MONITORING YEAR 3 ANNUAL REPORT

CROOKED CREEK #2 RESTORATION PROJECT

RE: Crooked Creek II Mitigation Site -Year 3 Monitoring Report
Final Submittal for DMS
DMS ID 94687
DEQ Contract Number D09126S
Yadkin Pee-Dee River Basin – CU# 03040105; Union County, NC

Wildlands Engineering, Inc. (Wildlands) has reviewed the Division of Mitigation Services (DMS) comments and observations from the Crooked Creek II Mitigation Site Draft Year 3 Monitoring Report. The following are Wildlands responses to your comments and observations from the report noted in italics lettering.

Figure 3.2 Integrated Current Condition Plan View
 Crooked Creek #2 Restoration Project
 DMS Project No. 94687
 Monitoring Year 3 - 2018
 Union County, NC

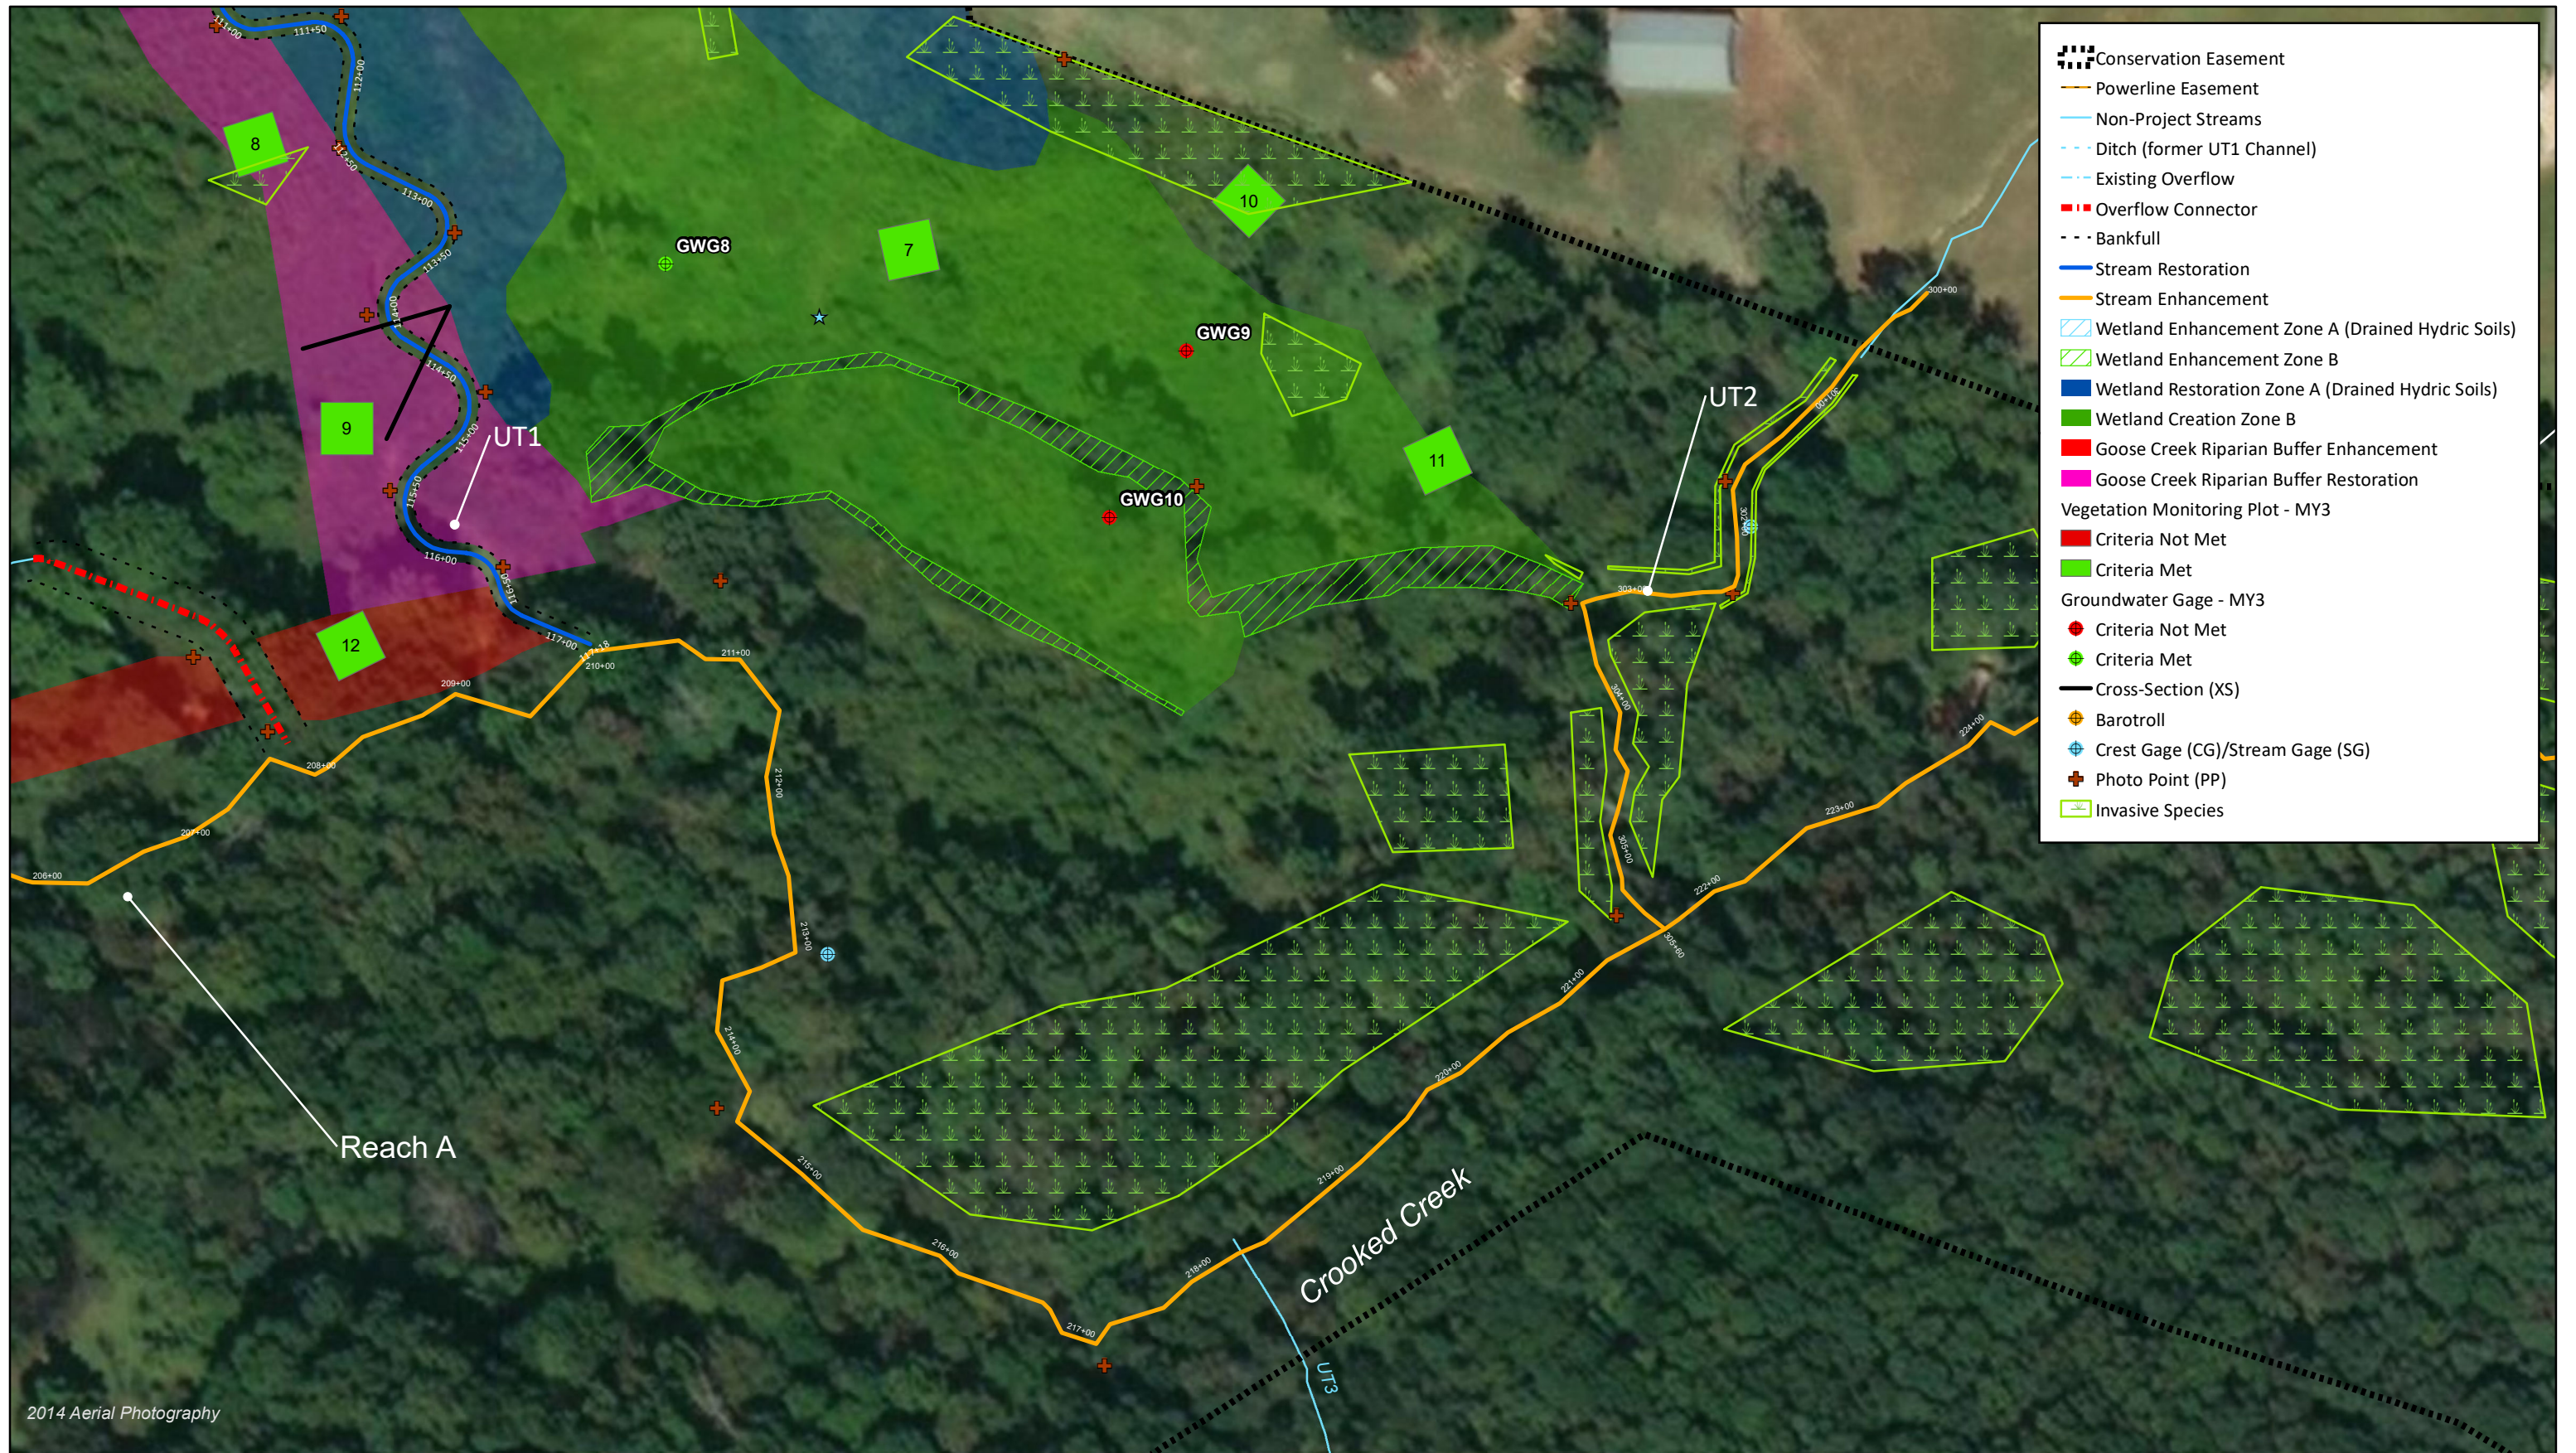
DMS Comment; CCPVs – If possible, please improve the report format/readability as follows: Use a stream centerline for Crooked Creek and UT2; the widened orange colors do not accurately represent the stream width; for example, sections of UT appear to be 50 feet wide.

DMS Comment Add station numbering for Crooked Creek and UT2.

DMS Comment Combine Sheets 1 and 2; and sheets 3,4,5; typically a project this size should not have 6 CCPVs to clearly depict monitoring features.

Wildlands Response; Wildlands updated the CCPV maps by inserting a stream centerline for Crooked Creek and UT2.

Wildlands Response; Wildlands added station numbers for Crooked Creek and UT2.

Wildlands Response; Wildlands combined the CCPV maps as requested.
